Product Label Change Notification for LSP Module Series (PCN# 4192E)

Littelfuse would like to notify you of a change related to the product label of LSP Module Series.

In order to clearly indicate product single pulse surge rating (I_{max}) and compliant with the terminology of voltage protection level (Up) from IEC61643-11 for LSP Module Series, we will start to add the “I_{max}” rating on existing labels for all LSP module products, and revise the “MLV” to “Up” for part numbers ending with suffix code of X3333 and X3316. There will be no changes to the electrical or dimensional specifications.

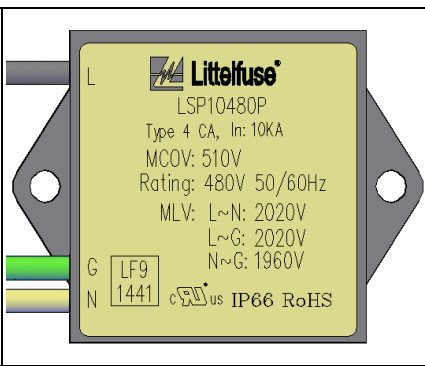
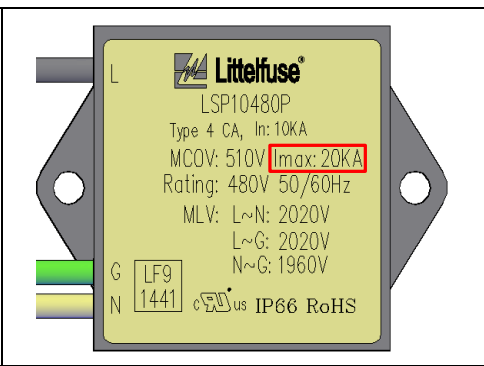
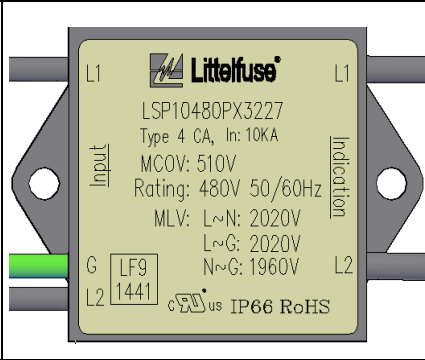
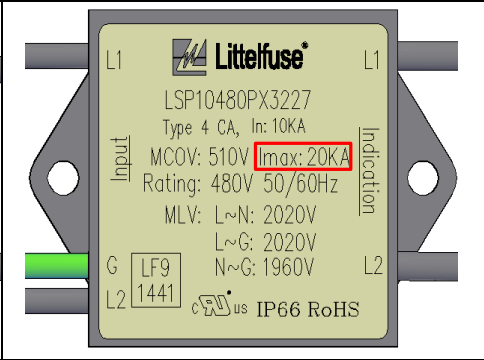
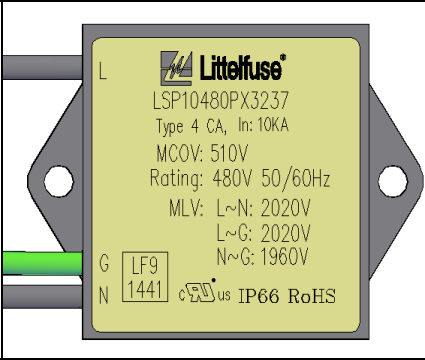
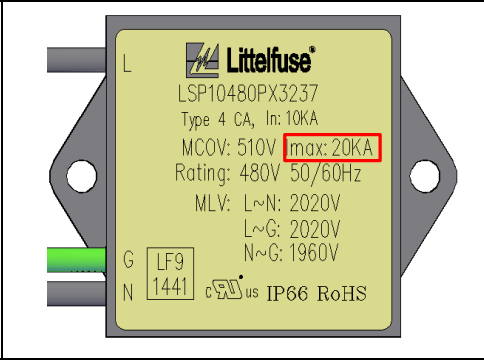
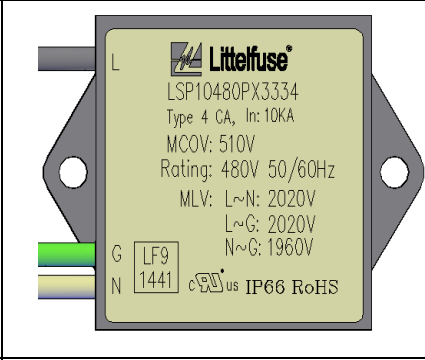
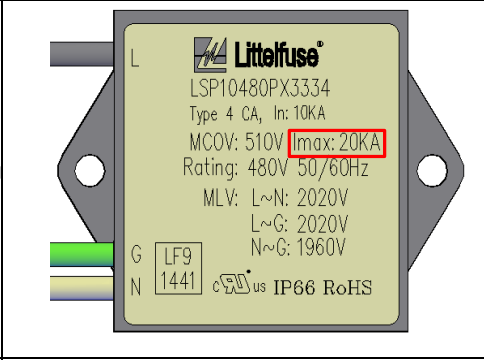
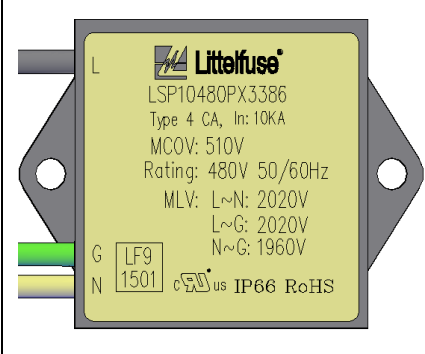
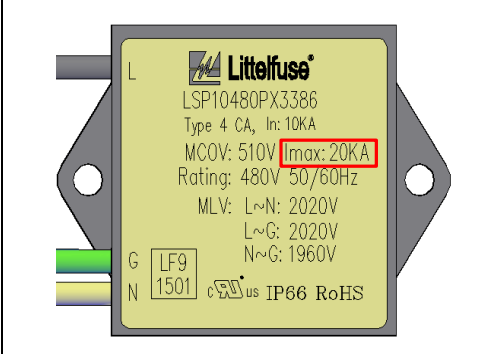
6	LSP10240S	 <p>Littelfuse® LSP10240S Type 4 CA, In: 10KA MCOV: 275V Rating: 240V 50/60Hz MLV: L~N: 1130V L~G: 1130V N~G: 1060V LF9 1441 cULus IP66 RoHS</p>	 <p>Littelfuse® LSP10240S Type 4 CA, In: 10KA MCOV: 275V I_{max}: 20KA Rating: 240V 50/60Hz MLV: L~N: 1130V L~G: 1130V N~G: 1060V LF9 1441 cULus IP66 RoHS</p>
7	LSP10240PX3316	 <p>Littelfuse® LSP10240PX3316 Type 4 CA, In: 10KA MCOV: 275V Rating: 240V 50/60Hz MLV: 1130V LF9 1441 cULus IP66 RoHS</p>	 <p>Littelfuse® LSP10240PX3316 Type 4 CA, In: 10KA MCOV: 275V I_{max}: 20KA Rating: 240V 50/60Hz Up: 1200V LF9 1441 cULus IP66 RoHS</p>
8	LSP10240PX3333	 <p>Littelfuse® LSP10240PX3333 Type 4 CA, In: 10KA MCOV: 275V Rating: 240V 50/60Hz MLV: L~N: 1130V L~G: 1130V N~G: 1060V LF9 1441 cULus IP66 RoHS</p>	 <p>Littelfuse® LSP10240PX3333 Type 4 CA, In: 10KA MCOV: 275V I_{max}: 20KA Rating: 240V 50/60Hz Up: 1200V LF9 1441 cULus IP66 RoHS</p>

9	LSP10240SX3316	 <p>Littelfuse® LSP10240SX3316 Type 4 CA, In: 10KA MCOV: 275V Rating: 240V 50/60Hz MLV: 1130V LF9 1441 cULus IP66 RoHS</p>	 <p>Littelfuse® LSP10240SX3316 Type 4 CA, In: 10KA MCOV: 275V I_{max}: 20KA Rating: 240V 50/60Hz Up: 1200V LF9 1441 cULus IP66 RoHS</p>
10	LSP10240SX3333	 <p>Littelfuse® LSP10240SX3333 Type 4 CA, In: 10KA MCOV: 275V Rating: 240V 50/60Hz MLV: L~N: 1130V L~G: 1130V N~G: 1060V LF9 1441 cULus IP66 RoHS</p>	 <p>Littelfuse® LSP10240SX3333 Type 4 CA, In: 10KA MCOV: 275V I_{max}: 20KA Rating: 240V 50/60Hz Up: 1200V LF9 1441 cULus IP66 RoHS</p>

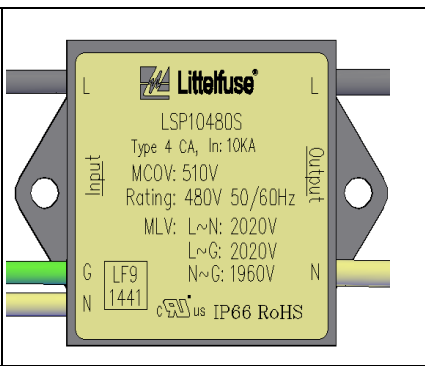
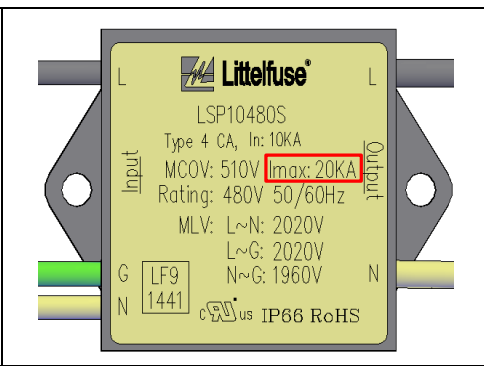
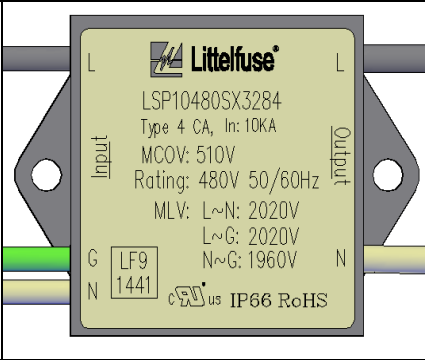
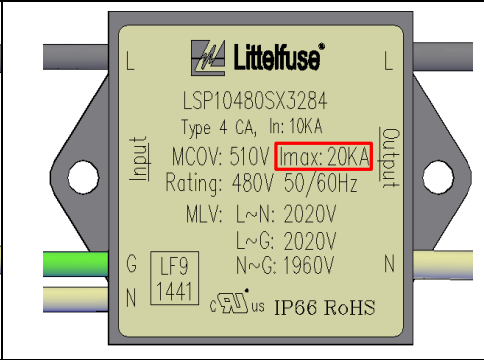
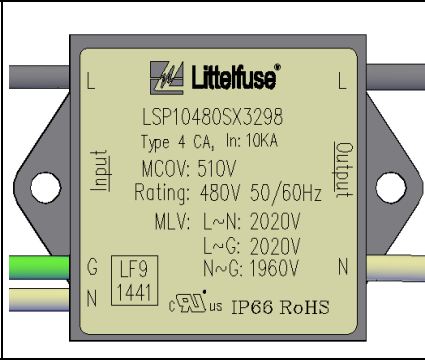
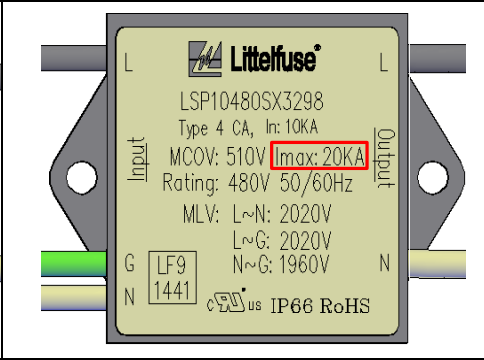
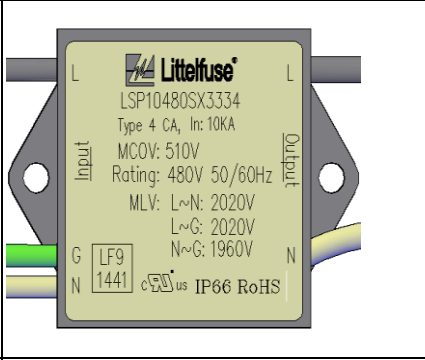
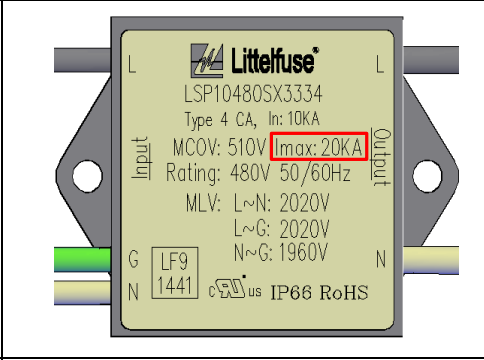
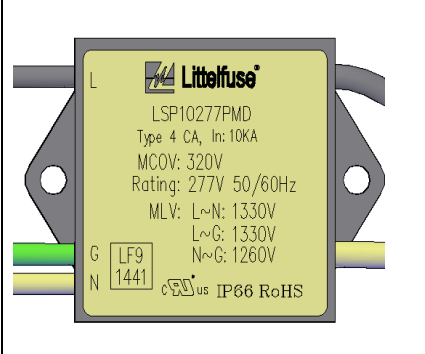
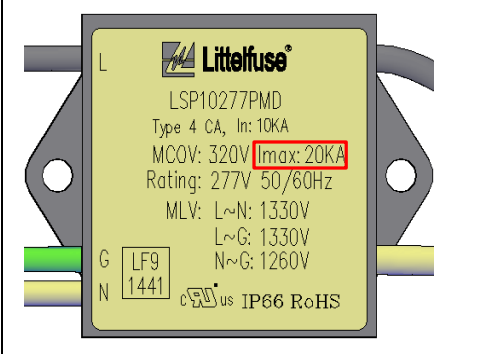
11	LSP10277P	 <p>L Littelfuse® LSP10277P Type 4 CA, In: 10KA MCOV: 320V Rating: 277V 50/60Hz MLV: L~N: 1330V L~G: 1330V N~G: 1260V G LF9 N 1441 cULus IP66 RoHS</p>	 <p>L Littelfuse® LSP10277P Type 4 CA, In: 10KA MCOV: 320V Imax: 20KA Rating: 277V 50/60Hz MLV: L~N: 1330V L~G: 1330V N~G: 1260V G LF9 N 1441 cULus IP66 RoHS</p>
12	LSP10277PX3226	 <p>L Littelfuse® LSP10277PX3226 Type 4 CA, In: 10KA MCOV: 320V Rating: 277V 50/60Hz MLV: L~N: 1330V L~G: 1330V N~G: 1260V G LF9 N 1441 cULus IP66 RoHS</p>	 <p>L Littelfuse® LSP10277PX3226 Type 4 CA, In: 10KA MCOV: 320V Imax: 20KA Rating: 277V 50/60Hz MLV: L~N: 1330V L~G: 1330V N~G: 1260V G LF9 N 1441 cULus IP66 RoHS</p>
13	LSP10277PX3227	 <p>L1 Littelfuse® LSP10277PX3227 Type 4 CA, In: 10KA MCOV: 320V Rating: 277V 50/60Hz MLV: L~N: 1330V L~G: 1330V N~G: 1260V G LF9 L2 1441 cULus IP66 RoHS Input Indication</p>	 <p>L1 Littelfuse® LSP10277PX3227 Type 4 CA, In: 10KA MCOV: 320V Imax: 20KA Rating: 277V 50/60Hz MLV: L~N: 1330V L~G: 1330V N~G: 1260V G LF9 L2 1441 cULus IP66 RoHS Input Indication</p>

14	LSP10277PX3237	 <p>L Littelfuse® LSP10277PX3237 Type 4 CA, In: 10KA MCOV: 320V Rating: 277V 50/60Hz MLV: L~N: 1330V L~G: 1330V N~G: 1260V G LF9 N 1441 cULus IP66 RoHS</p>	 <p>L Littelfuse® LSP10277PX3237 Type 4 CA, In: 10KA MCOV: 320V Imax: 20KA Rating: 277V 50/60Hz MLV: L~N: 1330V L~G: 1330V N~G: 1260V G LF9 N 1441 cULus IP66 RoHS</p>
15	LSP10277PX3284	 <p>L Littelfuse® LSP10277PX3284 Type 4 CA, In: 10KA MCOV: 320V Rating: 277V 50/60Hz MLV: L~N: 1330V L~G: 1330V N~G: 1260V G LF9 N 1441 cULus IP66 RoHS</p>	 <p>L Littelfuse® LSP10277PX3284 Type 4 CA, In: 10KA MCOV: 320V Imax: 20KA Rating: 277V 50/60Hz MLV: L~N: 1330V L~G: 1330V N~G: 1260V G LF9 N 1441 cULus IP66 RoHS</p>

16	LSP10277PX3316	 <p>L Littelfuse® LSP10277PX3316 Type 4 CA, In: 10KA MCOV: 320V Rating: 277V 50/60Hz MLV: 1330V LF9 1441 N cES us CE IP66 RoHS</p>	 <p>L Littelfuse® LSP10277PX3316 Type 4 CA, In: 10KA MCOV: 320V I_{max}: 20KA Rating: 277V 50/60Hz Up: 1400V LF9 1441 N cES us CE IP66 RoHS</p>
17	LSP10277PX3333	 <p>L Littelfuse® LSP10277PX3333 Type 4 CA, In: 10KA MCOV: 320V Rating: 277V 50/60Hz MLV: L~N: 1330V L~G: 1330V N~G: 1260V LF9 1441 G N cES us CE IP66 RoHS</p>	 <p>L Littelfuse® LSP10277PX3333 Type 4 CA, In: 10KA MCOV: 320V I_{max}: 20KA Rating: 277V 50/60Hz Up: 1400V LF9 1441 G N cES us CE IP66 RoHS</p>
18	LSP10277PX3334	 <p>L Littelfuse® LSP10277PX3334 Type 4 CA, In: 10KA MCOV: 320V Rating: 277V 50/60Hz MLV: L~N: 1330V L~G: 1330V N~G: 1260V LF9 1441 G N cES us IP66 RoHS</p>	 <p>L Littelfuse® LSP10277PX3334 Type 4 CA, In: 10KA MCOV: 320V I_{max}: 20KA Rating: 277V 50/60Hz MLV: L~N: 1330V L~G: 1330V N~G: 1260V LF9 1441 G N cES us IP66 RoHS</p>

19	LSP10277PX3386	 <p>L Littelfuse® LSP10277PX3386 Type 4 CA, In: 10KA MCOV: 320V Rating: 277V 50/60Hz MLV: L~N: 1330V L~G: 1330V N~G: 1260V LF9 1501 G N cES us IP66 RoHS</p>	 <p>L Littelfuse® LSP10277PX3386 Type 4 CA, In: 10KA MCOV: 320V I_{max}: 20KA Rating: 277V 50/60Hz MLV: L~N: 1330V L~G: 1330V N~G: 1260V LF9 1501 G N cES us IP66 RoHS</p>
20	LSP10277S	 <p>L Littelfuse® LSP10277S Type 4 CA, In: 10KA MCOV: 320V Rating: 277V 50/60Hz MLV: L~N: 1330V L~G: 1330V N~G: 1260V LF9 1441 G N cES us IP66 RoHS Input Output</p>	 <p>L Littelfuse® LSP10277S Type 4 CA, In: 10KA MCOV: 320V I_{max}: 20KA Rating: 277V 50/60Hz MLV: L~N: 1330V L~G: 1330V N~G: 1260V LF9 1441 G N cES us IP66 RoHS Input Output</p>

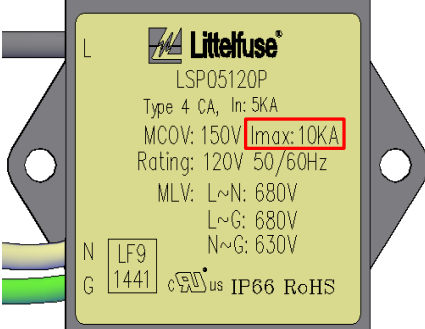
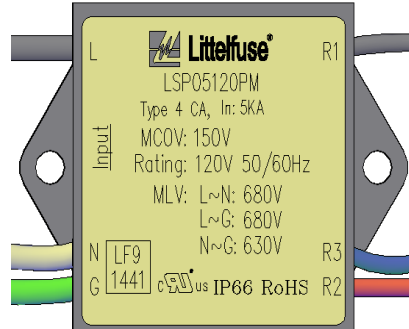
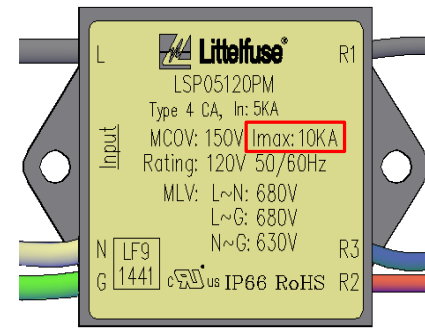
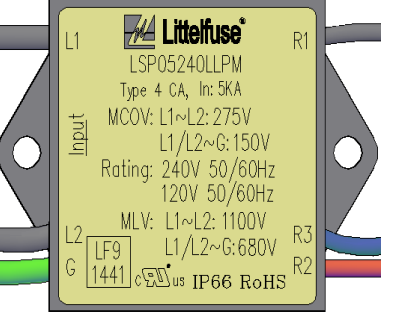
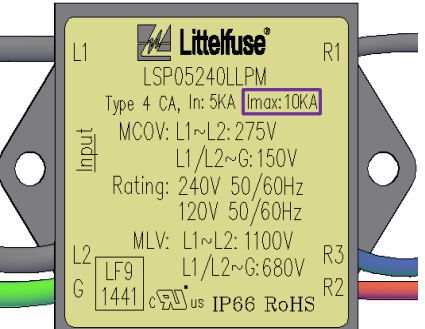
21	LSP10277SX3269	 <p> Littelfuse LSP10277SX3269 Type 4 CA, In: 10KA MCOV: 320V Rating: 277V 50/60Hz MLV: L~N: 1330V L~G: 1330V N~G: 1260V LF9 1441 IP66 RoHS </p>	 <p> Littelfuse LSP10277SX3269 Type 4 CA, In: 10KA MCOV: 320V Imax: 20KA Rating: 277V 50/60Hz MLV: L~N: 1330V L~G: 1330V N~G: 1260V LF9 1441 IP66 RoHS </p>
22	LSP10277SX3284	 <p> Littelfuse LSP10277SX3284 Type 4 CA, In: 10KA MCOV: 320V Rating: 277V 50/60Hz MLV: L~N: 1330V L~G: 1330V N~G: 1260V LF9 1441 IP66 RoHS </p>	 <p> Littelfuse LSP10277SX3284 Type 4 CA, In: 10KA MCOV: 320V Imax: 20KA Rating: 277V 50/60Hz MLV: L~N: 1330V L~G: 1330V N~G: 1260V LF9 1441 IP66 RoHS </p>
23	LSP10277SX3298	 <p> Littelfuse LSP10277SX3298 Type 4 CA, In: 10KA MCOV: 320V Rating: 277V 50/60Hz MLV: L~N: 1330V L~G: 1330V N~G: 1260V LF9 1441 IP66 RoHS </p>	 <p> Littelfuse LSP10277SX3298 Type 4 CA, In: 10KA MCOV: 320V Imax: 20KA Rating: 277V 50/60Hz MLV: L~N: 1330V L~G: 1330V N~G: 1260V LF9 1441 IP66 RoHS </p>

24	LSP10277SX3316	 <p> Littelfuse LSP10277SX3316 Type 4 CA, In: 10KA MCOV: 320V Rating: 277V 50/60Hz MLV: 1330V LF9 1441 IP66 RoHS </p>	 <p> Littelfuse LSP10277SX3316 Type 4 CA, In: 10KA MCOV: 320V Imax: 20KA Rating: 277V 50/60Hz Up: 1400V LF9 1441 IP66 RoHS </p>
25	LSP10277SX3333	 <p> Littelfuse LSP10277SX3333 Type 4 CA, In: 10KA MCOV: 320V Rating: 277V 50/60Hz MLV: L~N: 1330V L~G: 1330V N~G: 1260V LF9 1441 IP66 RoHS </p>	 <p> Littelfuse LSP10277SX3333 Type 4 CA, In: 10KA MCOV: 320V Imax: 20KA Rating: 277V 50/60Hz Up: 1400V LF9 1441 IP66 RoHS </p>

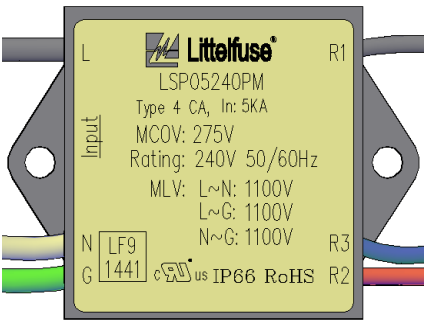
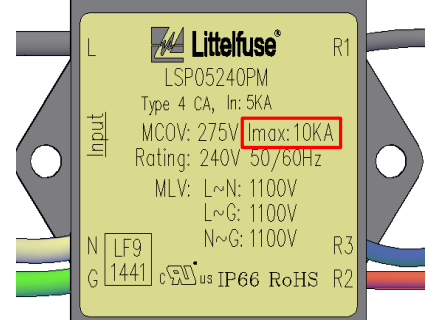
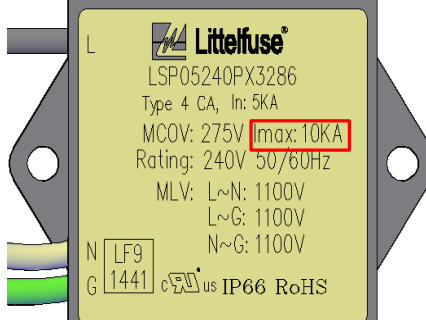
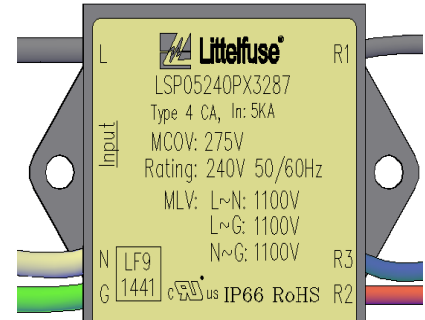
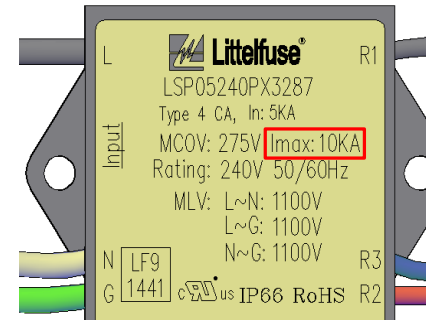
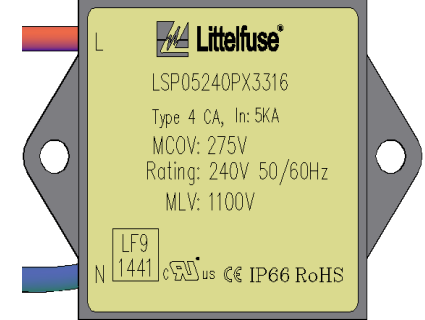
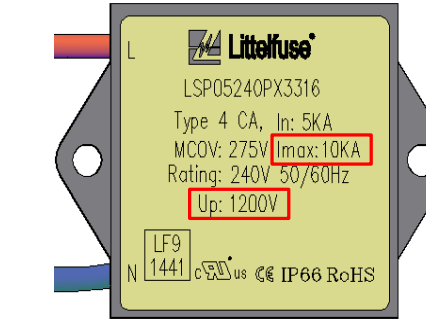
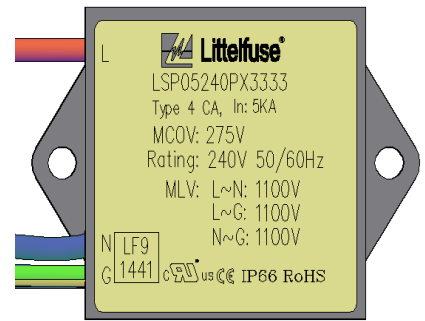
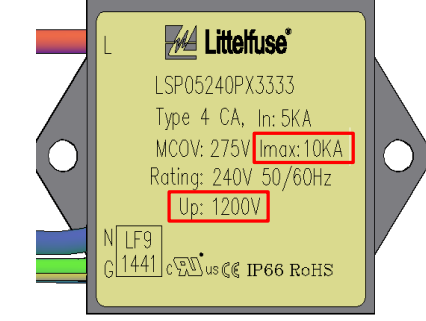
26	LSP10277SX3334	 <p> Littelfuse LSP10277SX3334 Type 4 CA, In: 10KA MCOV: 320V Rating: 277V 50/60Hz MLV: L~N: 1330V L~G: 1330V N~G: 1260V LF9 1441 IP66 RoHS </p>	 <p> Littelfuse LSP10277SX3334 Type 4 CA, In: 10KA MCOV: 320V Imax: 20KA Rating: 277V 50/60Hz MLV: L~N: 1330V L~G: 1330V N~G: 1260V LF9 1441 IP66 RoHS </p>
27	LSP10347P	 <p> Littelfuse LSP10347P Type 4 CA, In: 10KA MCOV: 420V Rating: 347V 50/60Hz MLV: L~N: 1750V L~G: 1750V N~G: 1680V LF9 1441 IP66 RoHS </p>	 <p> Littelfuse LSP10347P Type 4 CA, In: 10KA MCOV: 420V Imax: 20KA Rating: 347V 50/60Hz MLV: L~N: 1750V L~G: 1750V N~G: 1680V LF9 1441 IP66 RoHS </p>
28	LSP10347S	 <p> Littelfuse LSP10347S Type 4 CA, In: 10KA MCOV: 420V Rating: 347V 50/60Hz MLV: L~N: 1750V L~G: 1750V N~G: 1680V LF9 1441 IP66 RoHS </p>	 <p> Littelfuse LSP10347S Type 4 CA, In: 10KA MCOV: 420V Imax: 20KA Rating: 347V 50/60Hz MLV: L~N: 1750V L~G: 1750V N~G: 1680V LF9 1441 IP66 RoHS </p>

29	LSP10480LLP	 <p> Littelfuse LSP10480LLP Type 4 CA, In: 10KA MCOV: L1~L2: 510V L1/L2~G: 320V Rating: 480V 50/60Hz 277V 50/60Hz MLV: L1~L2: 2020V L1/L2~G: 1330V LF9 1441 IP66 RoHS </p>	 <p> Littelfuse LSP10480LLP Type 4 CA, In: 10KA Imax: 20KA MCOV: L1~L2: 510V L1/L2~G: 320V Rating: 480V 50/60Hz 277V 50/60Hz MLV: L1~L2: 2020V L1/L2~G: 1330V LF9 1441 IP66 RoHS </p>
30	LSP10480LLS	 <p> Littelfuse LSP10480LLS Type 4 CA, In: 10KA MCOV: L1~L2: 510V L1/L2~G: 320V Rating: 480V 50/60Hz 277V 50/60Hz MLV: L1~L2: 2020V L1/L2~G: 1330V LF9 1441 IP66 RoHS </p>	 <p> Littelfuse LSP10480LLS Type 4 CA, In: 10KA Imax: 20KA MCOV: L1~L2: 510V L1/L2~G: 320V Rating: 480V 50/60Hz 277V 50/60Hz MLV: L1~L2: 2020V L1/L2~G: 1330V LF9 1441 IP66 RoHS </p>

31	LSP10480P	 <p>L Littelfuse® LSP10480P Type 4 CA, In: 10KA MCOV: 510V Rating: 480V 50/60Hz MLV: L~N: 2020V L~G: 2020V N~G: 1960V G LF9 N 1441 c_{us} IP66 RoHS</p>	 <p>L Littelfuse® LSP10480P Type 4 CA, In: 10KA MCOV: 510V Imax: 20KA Rating: 480V 50/60Hz MLV: L~N: 2020V L~G: 2020V N~G: 1960V G LF9 N 1441 c_{us} IP66 RoHS</p>
32	LSP10480PX3227	 <p>L1 Littelfuse® LSP10480PX3227 Type 4 CA, In: 10KA MCOV: 510V Rating: 480V 50/60Hz MLV: L~N: 2020V L~G: 2020V N~G: 1960V G LF9 L2 1441 c_{us} IP66 RoHS</p> <p>Input Indication</p>	 <p>L1 Littelfuse® LSP10480PX3227 Type 4 CA, In: 10KA MCOV: 510V Imax: 20KA Rating: 480V 50/60Hz MLV: L~N: 2020V L~G: 2020V N~G: 1960V G LF9 L2 1441 c_{us} IP66 RoHS</p> <p>Input Indication</p>
33	LSP10480PX3237	 <p>L Littelfuse® LSP10480PX3237 Type 4 CA, In: 10KA MCOV: 510V Rating: 480V 50/60Hz MLV: L~N: 2020V L~G: 2020V N~G: 1960V G LF9 N 1441 c_{us} IP66 RoHS</p>	 <p>L Littelfuse® LSP10480PX3237 Type 4 CA, In: 10KA MCOV: 510V Imax: 20KA Rating: 480V 50/60Hz MLV: L~N: 2020V L~G: 2020V N~G: 1960V G LF9 N 1441 c_{us} IP66 RoHS</p>

34	LSP10480PX3334	 <p>L Littelfuse® LSP10480PX3334 Type 4 CA, In: 10KA MCOV: 510V Rating: 480V 50/60Hz MLV: L~N: 2020V L~G: 2020V N~G: 1960V G LF9 N 1441 c_{us} IP66 RoHS</p>	 <p>L Littelfuse® LSP10480PX3334 Type 4 CA, In: 10KA MCOV: 510V Imax: 20KA Rating: 480V 50/60Hz MLV: L~N: 2020V L~G: 2020V N~G: 1960V G LF9 N 1441 c_{us} IP66 RoHS</p>
35	LSP10480PX3386	 <p>L Littelfuse® LSP10480PX3386 Type 4 CA, In: 10KA MCOV: 510V Rating: 480V 50/60Hz MLV: L~N: 2020V L~G: 2020V N~G: 1960V G LF9 N 1501 c_{us} IP66 RoHS</p>	 <p>L Littelfuse® LSP10480PX3386 Type 4 CA, In: 10KA MCOV: 510V Imax: 20KA Rating: 480V 50/60Hz MLV: L~N: 2020V L~G: 2020V N~G: 1960V G LF9 N 1501 c_{us} IP66 RoHS</p>

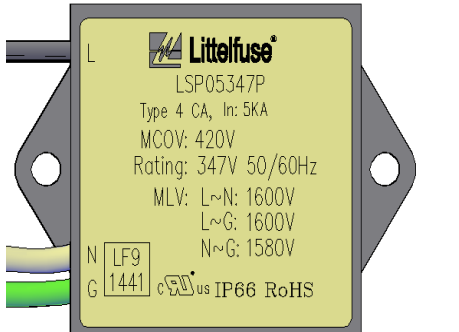
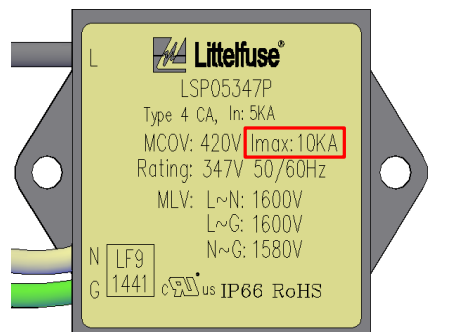
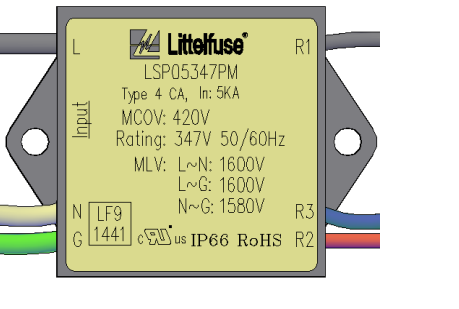
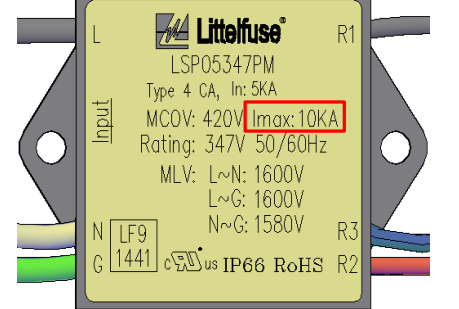
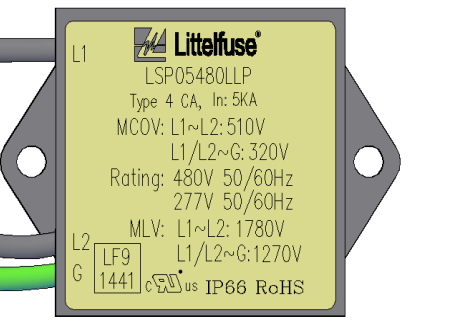
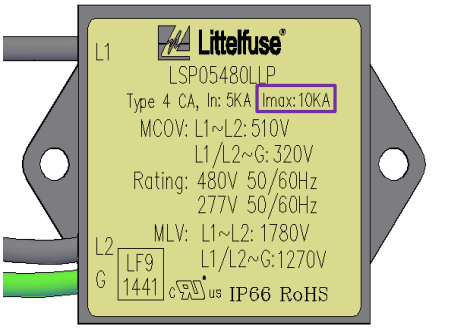
36	LSP10480S	 <p>Littelfuse LSP10480S Type 4 CA, In: 10KA MCOV: 510V Rating: 480V 50/60Hz MLV: L~N: 2020V L~G: 2020V N~G: 1960V LF9 1441 IP66 RoHS</p>	 <p>Littelfuse LSP10480S Type 4 CA, In: 10KA MCOV: 510V Imax: 20KA Rating: 480V 50/60Hz MLV: L~N: 2020V L~G: 2020V N~G: 1960V LF9 1441 IP66 RoHS</p>
37	LSP10480SX3284	 <p>Littelfuse LSP10480SX3284 Type 4 CA, In: 10KA MCOV: 510V Rating: 480V 50/60Hz MLV: L~N: 2020V L~G: 2020V N~G: 1960V LF9 1441 IP66 RoHS</p>	 <p>Littelfuse LSP10480SX3284 Type 4 CA, In: 10KA MCOV: 510V Imax: 20KA Rating: 480V 50/60Hz MLV: L~N: 2020V L~G: 2020V N~G: 1960V LF9 1441 IP66 RoHS</p>
38	LSP10480SX3298	 <p>Littelfuse LSP10480SX3298 Type 4 CA, In: 10KA MCOV: 510V Rating: 480V 50/60Hz MLV: L~N: 2020V L~G: 2020V N~G: 1960V LF9 1441 IP66 RoHS</p>	 <p>Littelfuse LSP10480SX3298 Type 4 CA, In: 10KA MCOV: 510V Imax: 20KA Rating: 480V 50/60Hz MLV: L~N: 2020V L~G: 2020V N~G: 1960V LF9 1441 IP66 RoHS</p>

39	LSP10480SX3334	 <p>Littelfuse LSP10480SX3334 Type 4 CA, In: 10KA MCOV: 510V Rating: 480V 50/60Hz MLV: L~N: 2020V L~G: 2020V N~G: 1960V LF9 1441 IP66 RoHS</p>	 <p>Littelfuse LSP10480SX3334 Type 4 CA, In: 10KA MCOV: 510V Imax: 20KA Rating: 480V 50/60Hz MLV: L~N: 2020V L~G: 2020V N~G: 1960V LF9 1441 IP66 RoHS</p>
40	LSP10277PMD	 <p>Littelfuse LSP10277PMD Type 4 CA, In: 10KA MCOV: 320V Rating: 277V 50/60Hz MLV: L~N: 1330V L~G: 1330V N~G: 1260V LF9 1441 IP66 RoHS</p>	 <p>Littelfuse LSP10277PMD Type 4 CA, In: 10KA MCOV: 320V Imax: 20KA Rating: 277V 50/60Hz MLV: L~N: 1330V L~G: 1330V N~G: 1260V LF9 1441 IP66 RoHS</p>

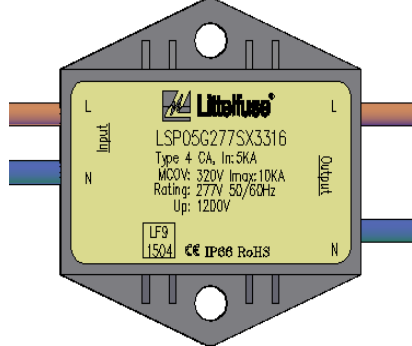
51	LSP05277P	 <p> Littelfuse LSP05277P Type 4 CA, In: 5KA MCOV: 320V Rating: 277V 50/60Hz MLV: L~N: 1270V L~G: 1270V N~G: 1220V N LF9 G 1441 cULus IP66 RoHS </p>	 <p> Littelfuse LSP05277P Type 4 CA, In: 5KA MCOV: 320V Imax:10KA Rating: 277V 50/60Hz MLV: L~N: 1270V L~G: 1270V N~G: 1220V N LF9 G 1441 cULus IP66 RoHS </p>
52	LSP05277PM	 <p> Littelfuse LSP05277PM Type 4 CA, In: 5KA MCOV: 320V Rating: 277V 50/60Hz MLV: L~N: 1270V L~G: 1270V N~G: 1220V N LF9 G 1441 cULus IP66 RoHS </p>	 <p> Littelfuse LSP05277PM Type 4 CA, In: 5KA MCOV: 320V Imax:10KA Rating: 277V 50/60Hz MLV: L~N: 1270V L~G: 1270V N~G: 1220V N LF9 G 1441 cULus IP66 RoHS </p>
53	LSP05277PX3316	 <p> Littelfuse LSP05277PX3316 Type 4 CA, In: 5KA MCOV: 320V Rating: 277V 50/60Hz MLV: 1270V N LF9 G 1441 cULus IP66 RoHS </p>	 <p> Littelfuse LSP05277PX3316 Type 4 CA, In: 5KA MCOV: 320V Imax:10KA Rating: 277V 50/60Hz Up: 1400V N LF9 G 1441 cULus IP66 RoHS </p>

54	LSP05277PMX3316	 <p> Littelfuse LSP05277PMX3316 Type 4 CA, In: 5KA MCOV: 320V Rating: 277V 50/60Hz MLV: 1270V N LF9 G 1441 cULus IP66 RoHS </p>	 <p> Littelfuse LSP05277PMX3316 Type 4 CA, In: 5KA MCOV: 320V Imax:10KA Rating: 277V 50/60Hz Up: 1400V N LF9 G 1441 cULus IP66 RoHS </p>
55	LSP05277PX3333	 <p> Littelfuse LSP05277PX3333 Type 4 CA, In: 5KA MCOV: 320V Rating: 277V 50/60Hz MLV: L~N: 1270V L~G: 1270V N~G: 1220V N LF9 G 1441 cULus IP66 RoHS </p>	 <p> Littelfuse LSP05277PX3333 Type 4 CA, In: 5KA MCOV: 320V Imax:10KA Rating: 277V 50/60Hz Up: 1400V N LF9 G 1441 cULus IP66 RoHS </p>
